Name of Proposed Development Hillcrest Shores

File No.: 93-30-FP/2

Reference: North Lakeshore Drive
Traffic Safety Study

Please accept our final recommendations regarding the Preliminary land study for Phase I and II of the proposed MAHR Development. This response is organized by Task authorized in our letter proposal dated July 7, 1993:

FIGURE 6

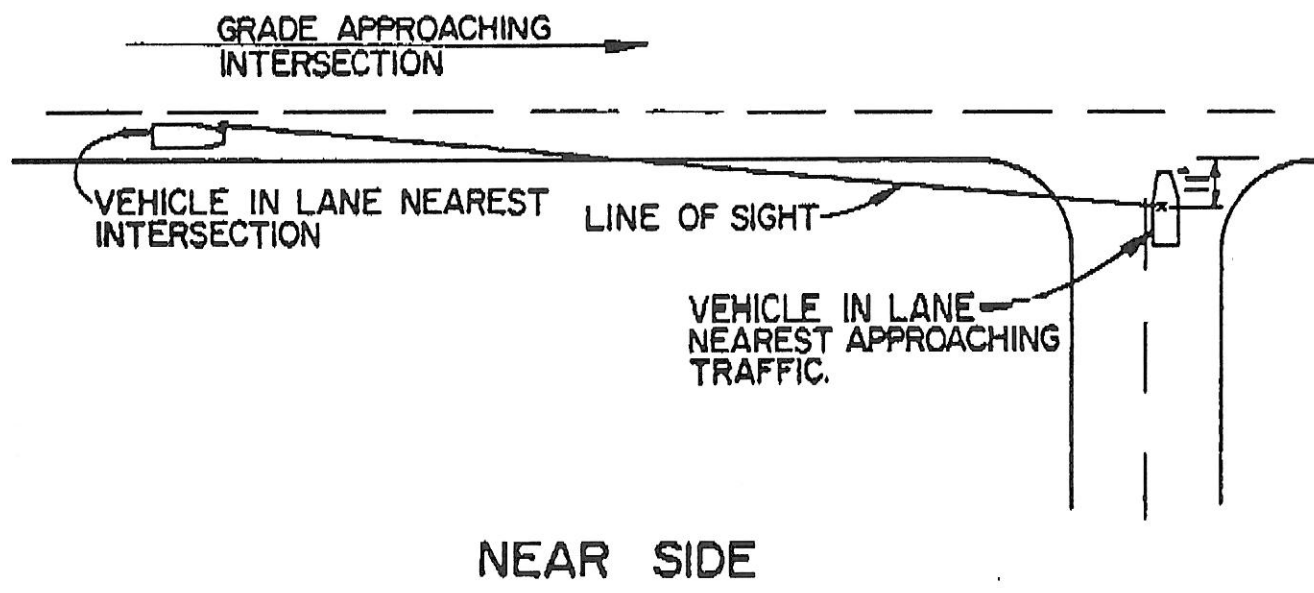
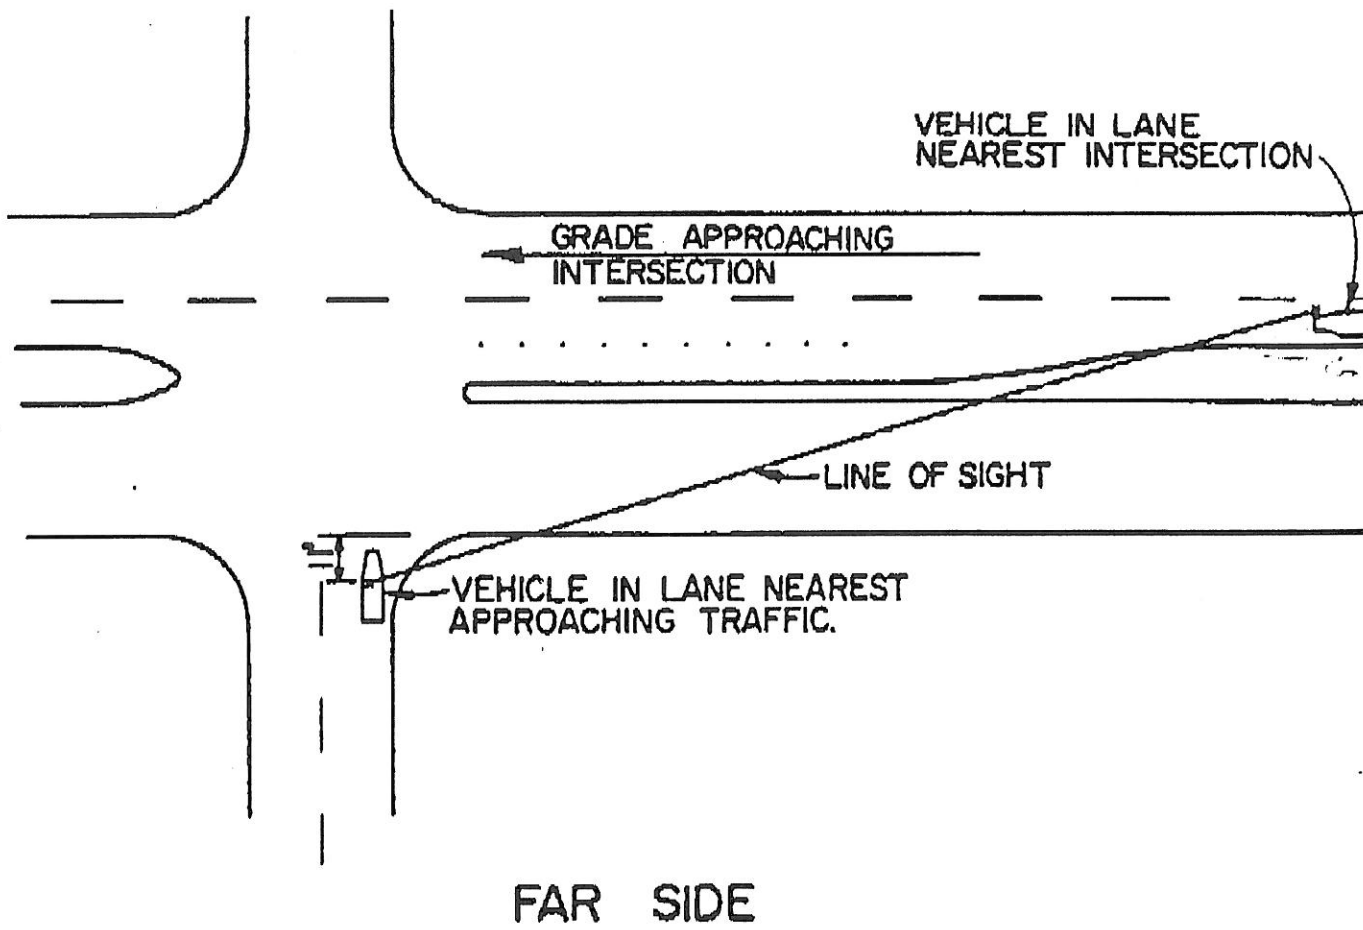
Intersection Station 1+15 from left. (Sheet 4 of 18)

This intersection has sight distance in both directions to accommodate the design speed of 40 mph on North Lakeshore Drive.

Intersection approximate Station 3+60 from left. (Sheet 4 of 18)

This intersection has sight distance on the near side to accommodate the design speed of 40 mph on North Lakeshore Drive. The stopping sight distance on far side is 275 ft.

Intersection approximate Station 6+45 from left. (Sheet 4 of 18)

This intersection has sight distance on the far side to accommodate the design speed of 40 mph on North Lakeshore Drive. The stopping sight distance on near side is 275 ft.

Intersection approximate Station 11+30 from left. (Sheet 5 of 18)

This intersection has sight distance on the far side to accommodate the design speed of 40 mph on North Lakeshore Drive. The stopping sight distance on near side is 275 ft.

Alleys approximate Station 2+55 and Station 5+05. (Sheet 4 of 18)

These alleys have sight distance in both directions to accommodate the design speed of 40 mph on North Lakeshore Drive.

Alley approximate Station 8+90 Left.

This alley has sight distance on the far side to accommodate the design speed of 40 mph on North Lakeshore Drive. The stopping distance on near side of 275 ft.

The 1973 AASHO design required a minimum SSD of 275 ft and desirable SSD of 300 ft. The above streets and alleys appear to meet the minimum for the old criteria as noted. However, it is critical that the City prohibit fences, landscaping and other obstructions to be placed in the sight triangles at each intersection.

FIGURE 2.2

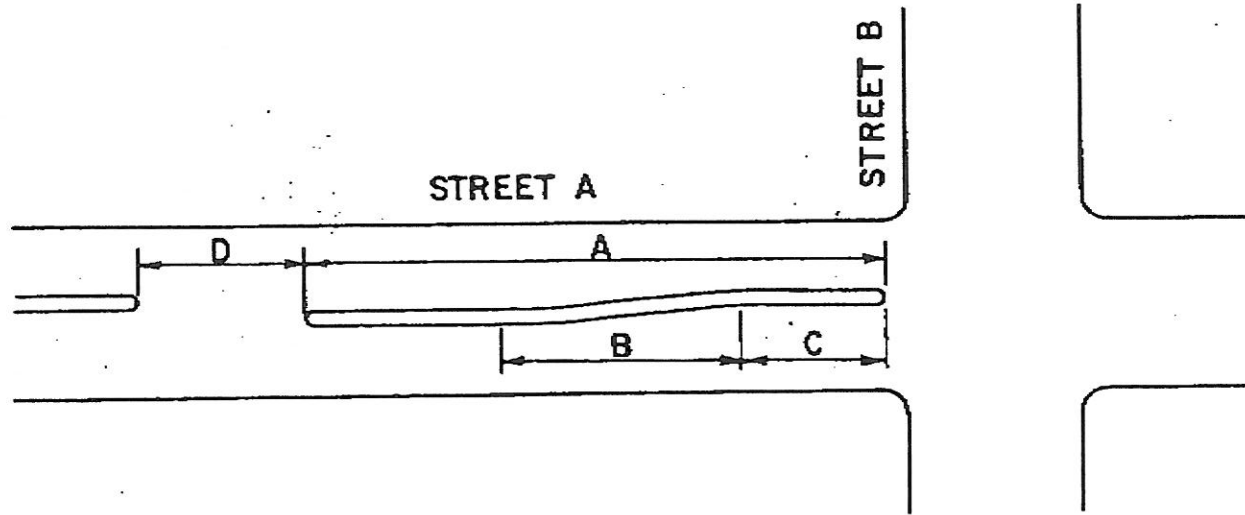
The City may wish to eliminate median openings for alleys to meet the proposed median design standards (Fig. 2.2).

PROPOSED TRANSITION

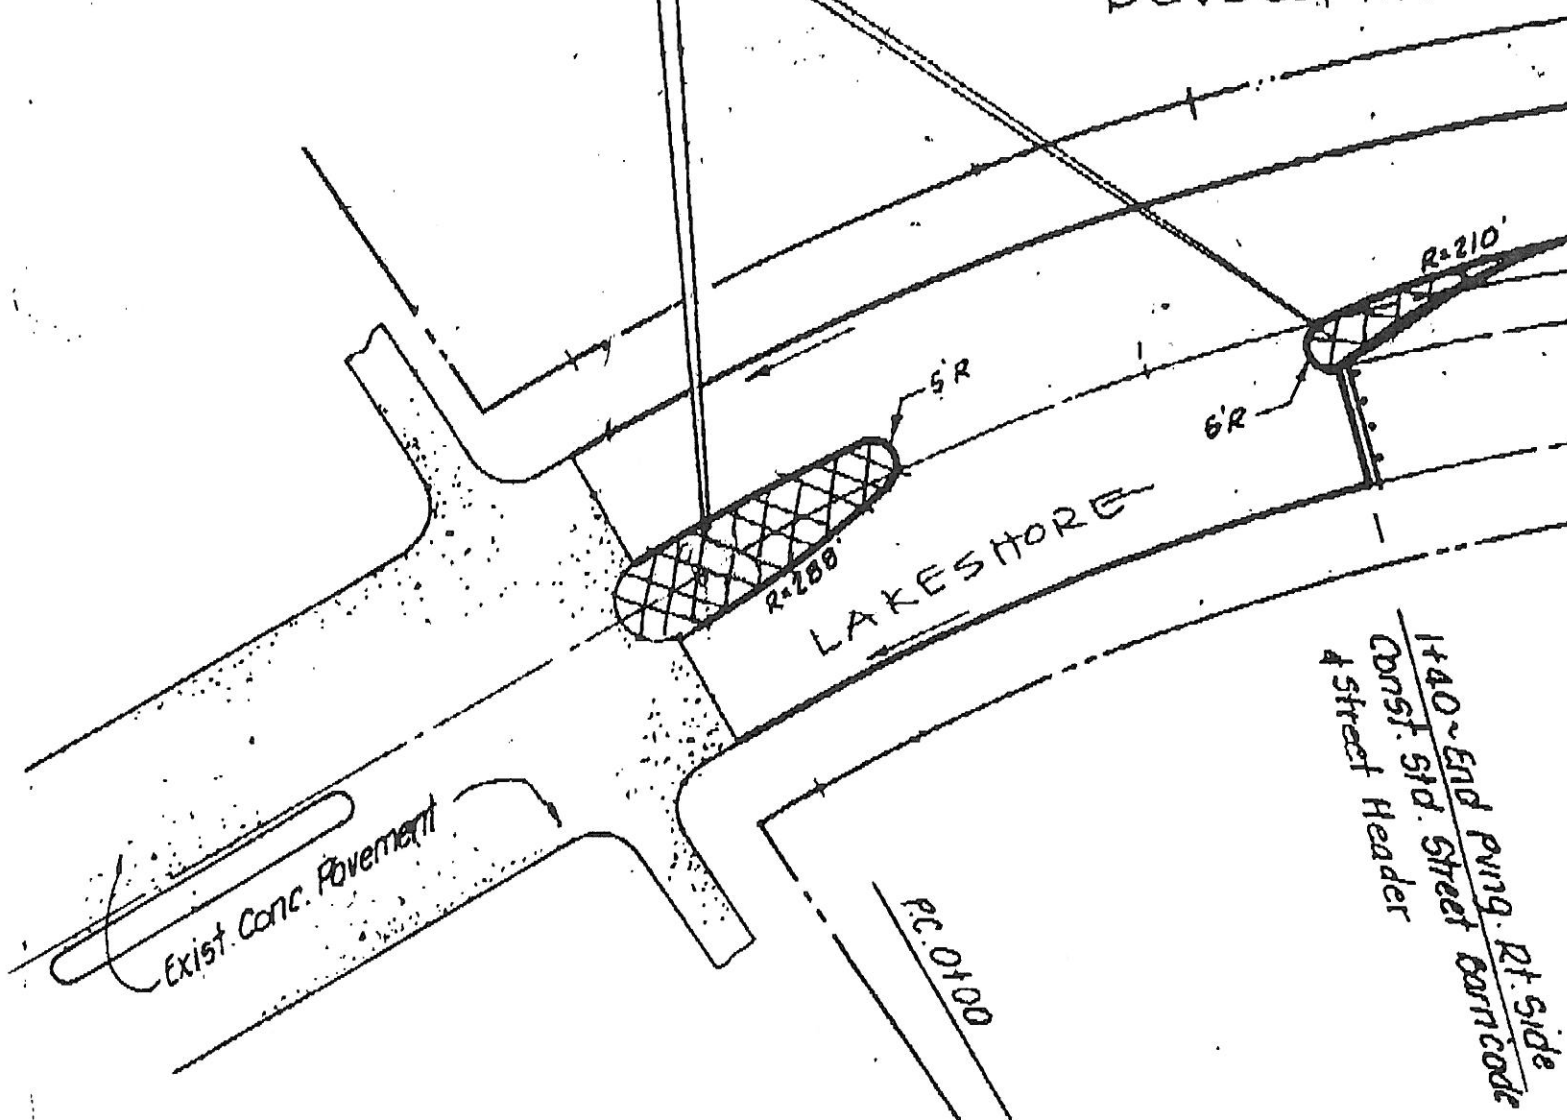
A temporary transition of this type is always awkward and somewhat unsightly until the remaining two lanes can be extended. The existing condition in the field does not comply with the Texas Manual on Uniform Traffic Control Devices (TMUTCD) for advance Warning Signs, Pavement Markings and Barricades. We recommend that the transition be reconstructed as illustrated in the attached concept sketch and that a signing and marking plan that complies with the TMUTCD be implemented.

North Lakeshore Drive Hourly Traffic Volumes vs. NCTCOG Service Volumes

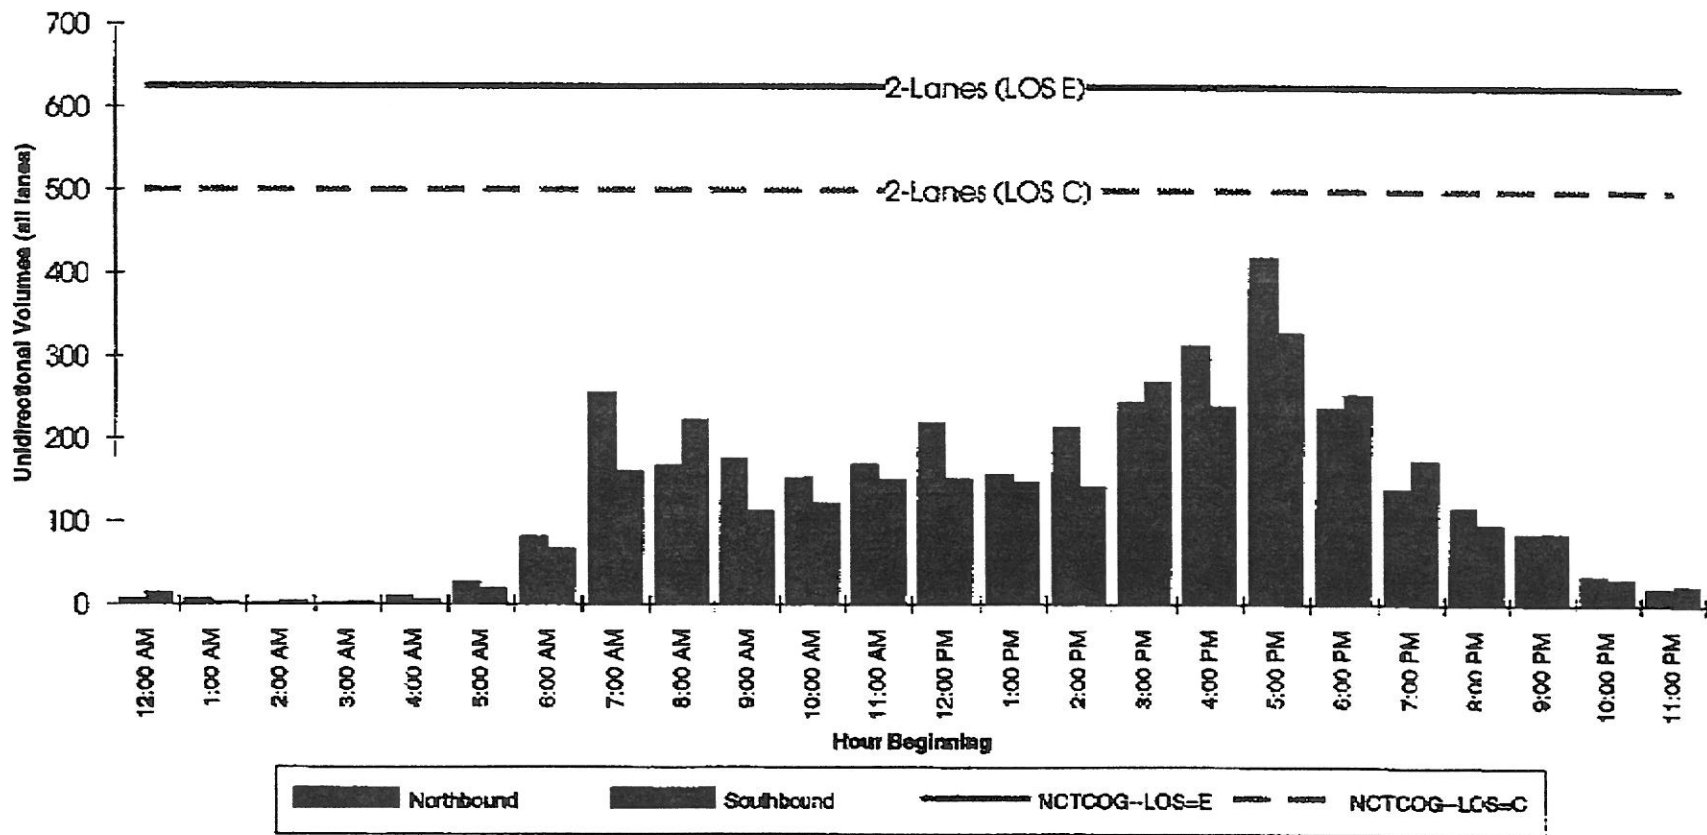
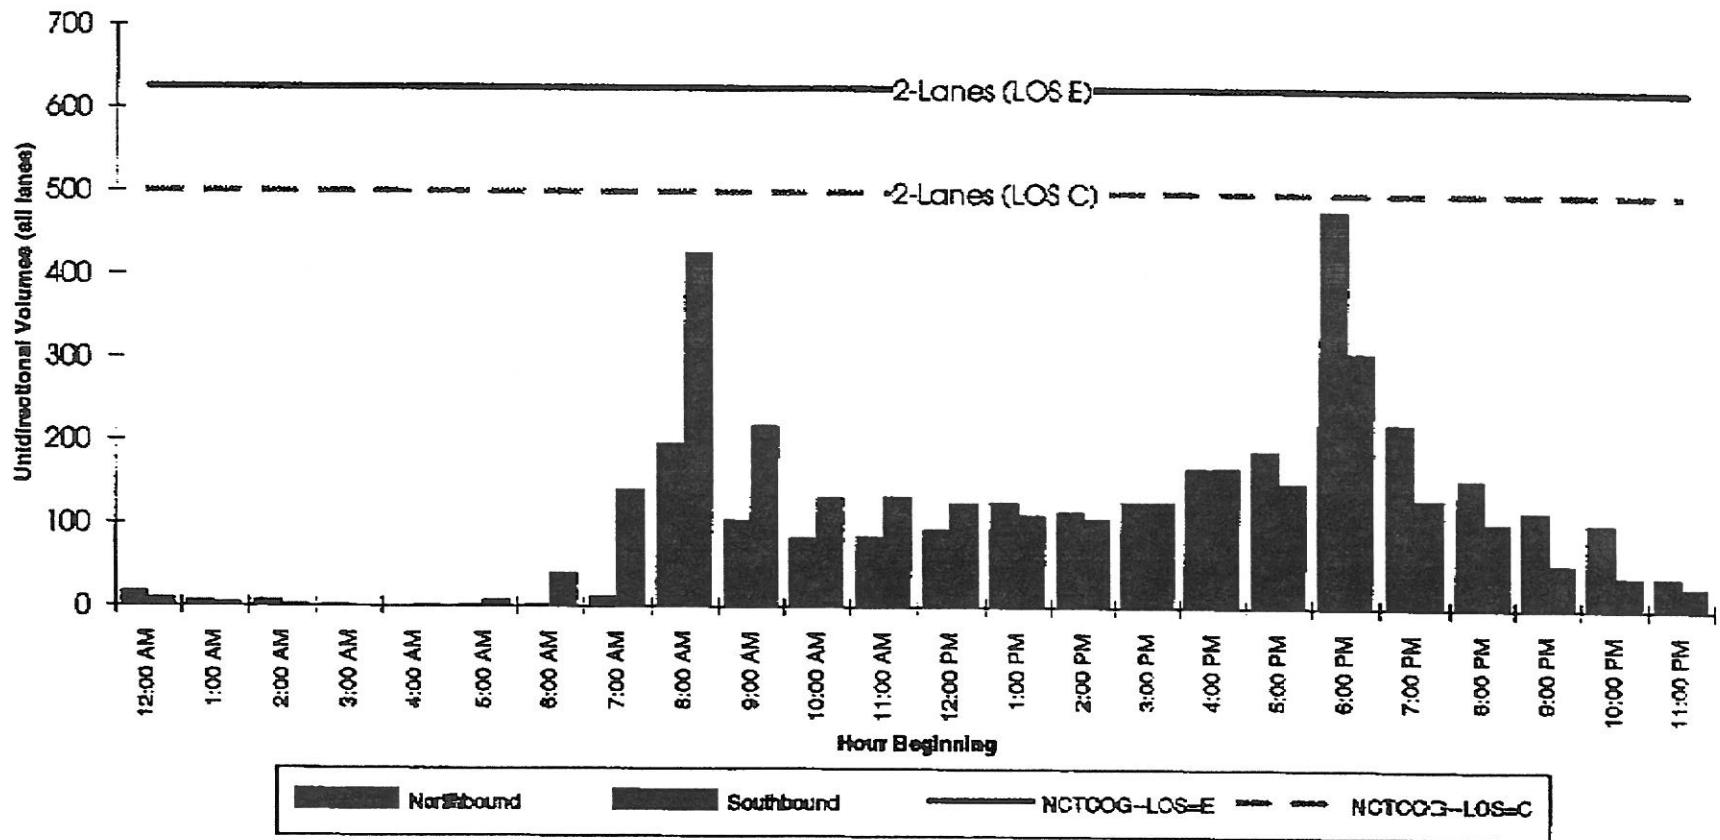
The attached graphs illustrate how the existing traffic volumes compare to the two levels of service described above. The first graph shows the traffic volumes currently found on Lakeshore Drive. The second graph shows how these volumes will increase with the new development planned for the west side of Lakeshore Drive.

As the graphs show, the current two-lane undivided configuration of Lakeshore Drive is adequate to provide LOS C operational quality with full build-out of the MAHR Development.
